ULNRC-2714

CALLAWAY PLANT
DOCKET NUMBER 50-483
ADDITIONAL INFORMATION REGARDING
REVISION TO TECHNICAL SPECIFICATION TABLE 3.3-4,
"ENGINEERED SAFETY FEATURES ACTUATION SYSTEM
INSTRUMENTATION TRIP SETPOINTS"

DEGRADED VOLTAGE SETPOINT REVISION AND VOLTAGE
SAFETY LIMIT ANALYSIS

DEGRADED VOLTAGE LOOP UNCERTAINTY BREAKDOWN AND PLANT LOAD FLOW ALLOWANCE

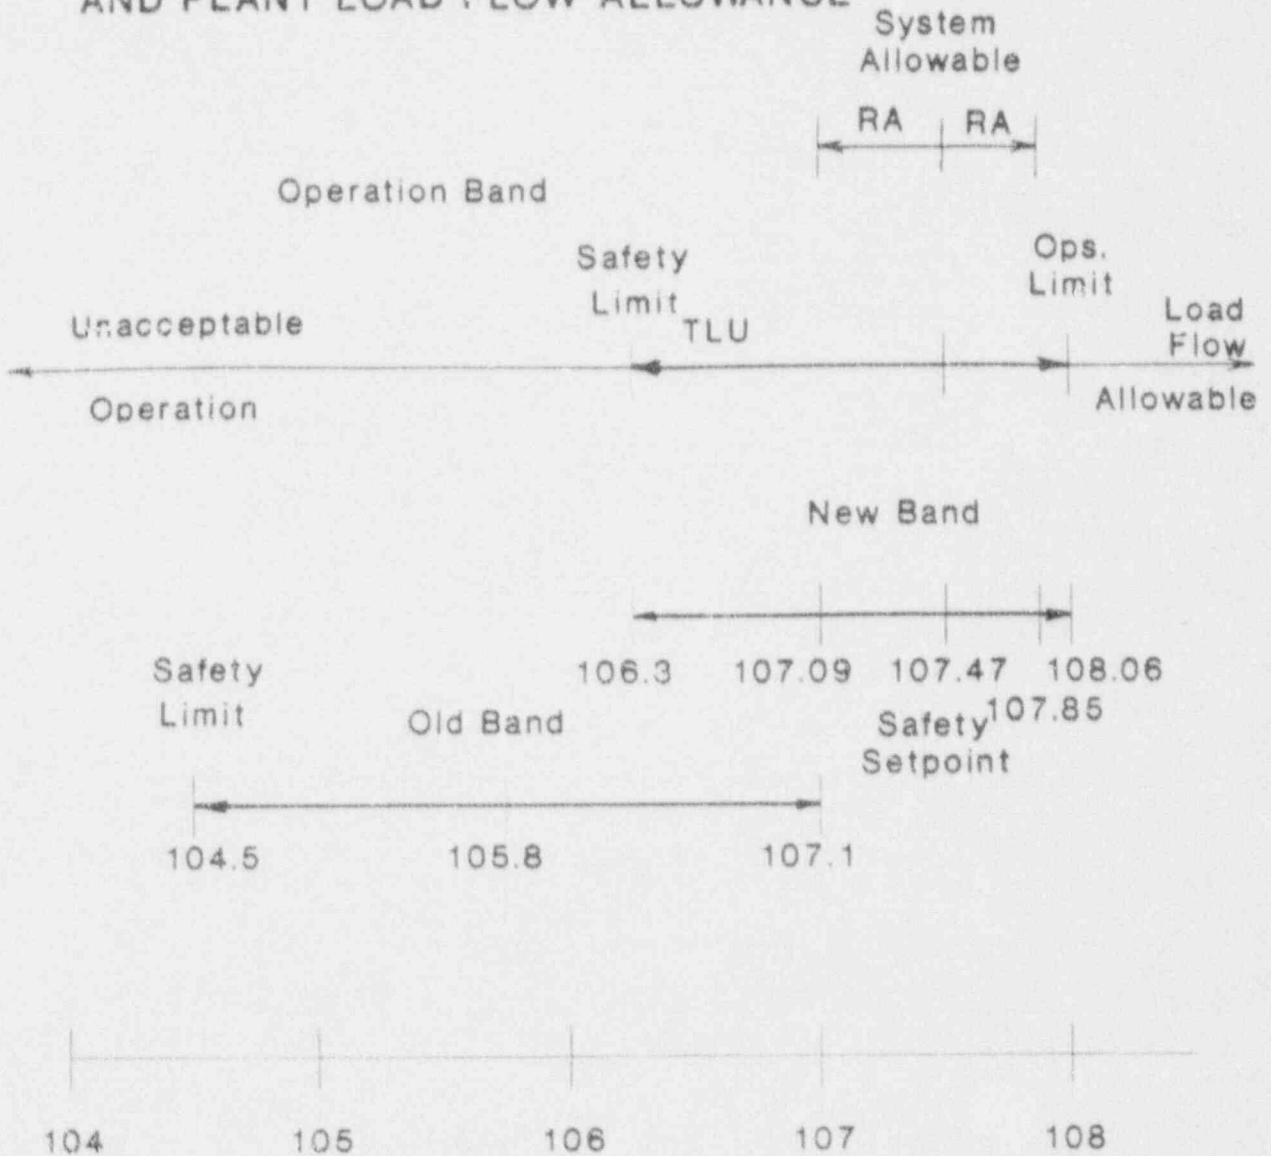
DESIGN CHANGE CMP 91-1034 REVISES THE DEGRADED VOLTAGE SETPOINT AND THE TOLERANCE FROM 104.5 +2.6/ - 0 VOLTS TO 107.47 +/- 0.38 VOLTS. THIS CHANGE INVOLVES A CHANGE TO THE PLANT TECHNICAL SPECIFICATIONS.

- 1) A REVISION IN THE ANALYSIS OF THE LOOP TOLERANCES USING ISA STANDARD DRP 67.04. --- CALLAWAY USES PROCEDURE J-U-GEN TO PERFORM THIS ANALYSIS.
- 2) A REVISION OF THE LOWER LIMIT OF THE DEGRADED VOLTAGE VOLTAGE SETPOINT BAND. --- THIS IS CONSIDERED AS A SAFETY LIMIT. THIS VOLTAGE LIMIT IS PRODUCED USING LOAD FLOW TECHNIQUES. THE LOAD FLOW CONSERVATISMS BASED ON INITIAL DESIGN ASSUMPTIONS ARE BEING REVISED USING ACTUAL COMPONENT DATA AND OPERATIONAL CONSIDERATIONS. THE RESULTS OF THIS ANALYSIS IS USED AS THE SAFETY LIMIT.
